MOUNT VERNON
HISTORICAL REVIEW COMMISSION
MINUTES • AUGUST 11, 2022

1. 2022-HRC-24 - 607 E High ST - Solar Panels

2022-HRC-24 - 607 E HIGH ST - SOLAR PANELS

NEW PHOTOVOLTAIC SYSTEM 5.04 KW DC

1 | **SITE PLAN**
SCALE: 1/16" = 1'-0"

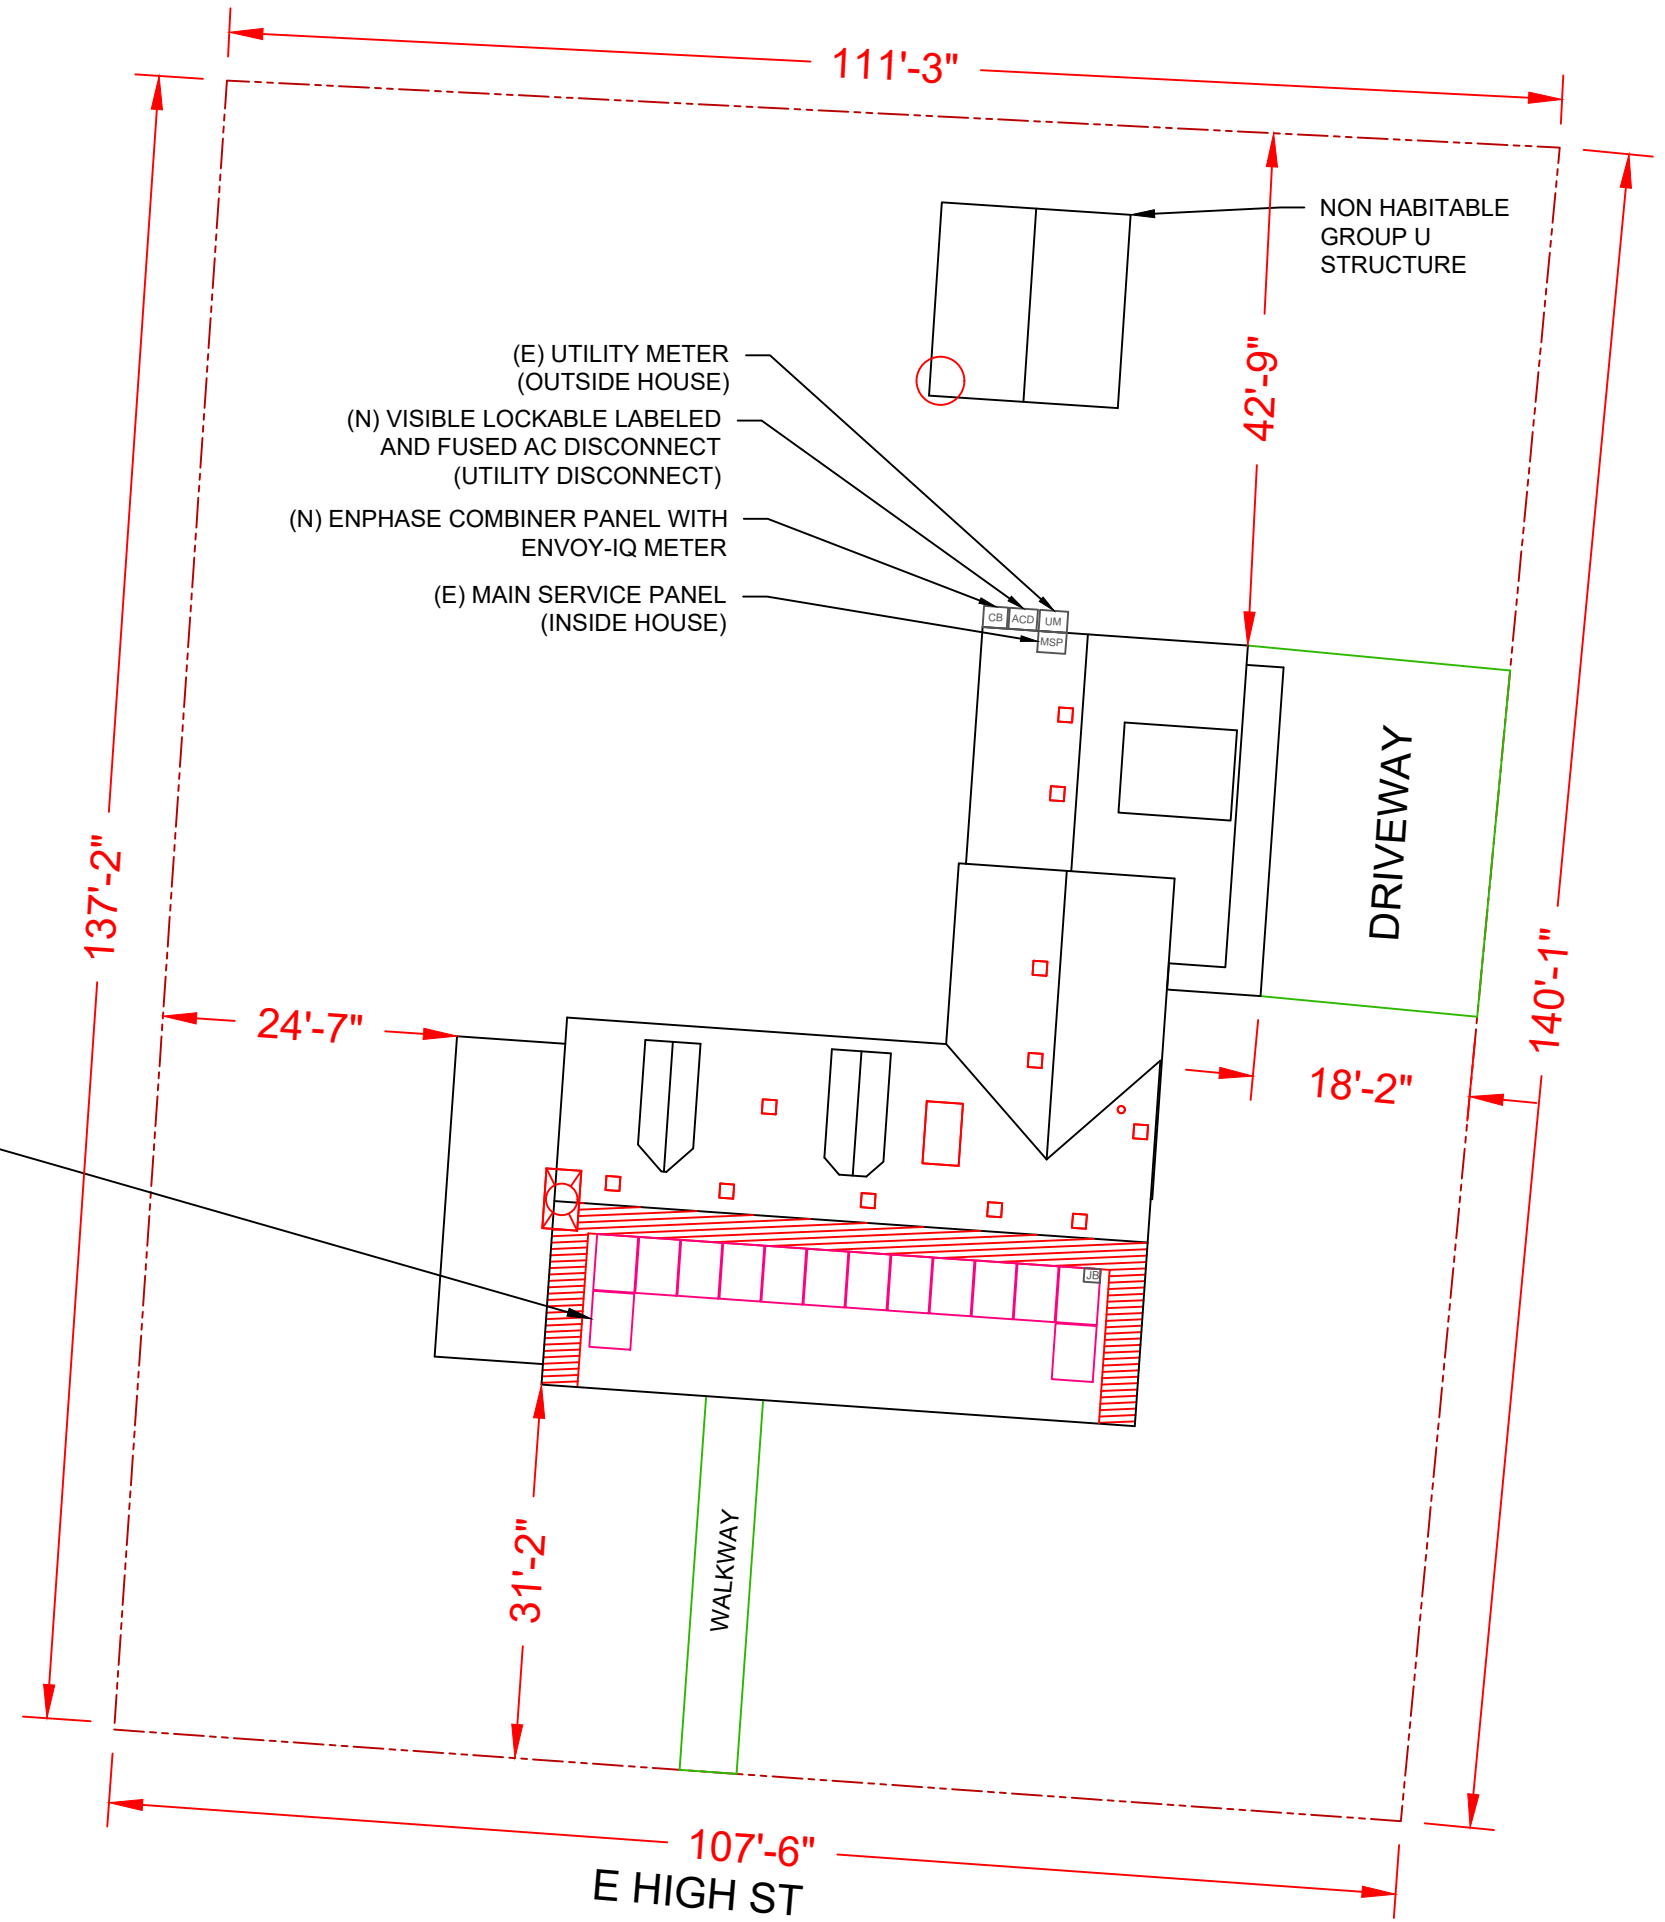
Riedmiller said fire code limits the number of panels along the roof line to 12. She proposed to move the 2 drop downs to a rear roof line behind the garage.

Dzik said he thinks what catches his attention is the 2 panels on the bottom. If there is a way to have a single strip or 2 equal strips, he thinks it will be much less noticeable.

Riedmiller said the 2 drop downs can be relocated. She is willing to purchase additional panels to obtain the same volume collected.

Dzik made a motion to amend the standing motion to approve a single strip of solar panels near the peak of the front roof line. The additional panels can be located at the back of the property. Warga seconded the amendment.

Riedmiller said fire code limits the number of panels along the roof line to 12. She proposed to move the 2 drop downs to a rear roof line behind the garage.

Dzik said he thinks what catches his attention is the 2 panels on the bottom. If there is a way to have a single strip or 2 equal strips, he thinks it will be much less noticeable.

Riedmiller said the 2 drop downs can be relocated. She is willing to purchase additional panels to obtain the same volume collected.

Dzik made a motion to amend the standing motion to approve a single strip of solar panels near the peak of the front roof line. The additional panels can be located at the back of the property. Warga seconded the amendment.

RESULT:	ACCEPT AS MODIFIED [UNANIMOUS]
MOVER:	Lacey Filkins, Member
SECONDER:	Julia Warga, Member
AYES:	Drews, Dzik, Filkins, Starr, Warga
EXCUSED:	Diehl, Hawkins, Poland, Swallow
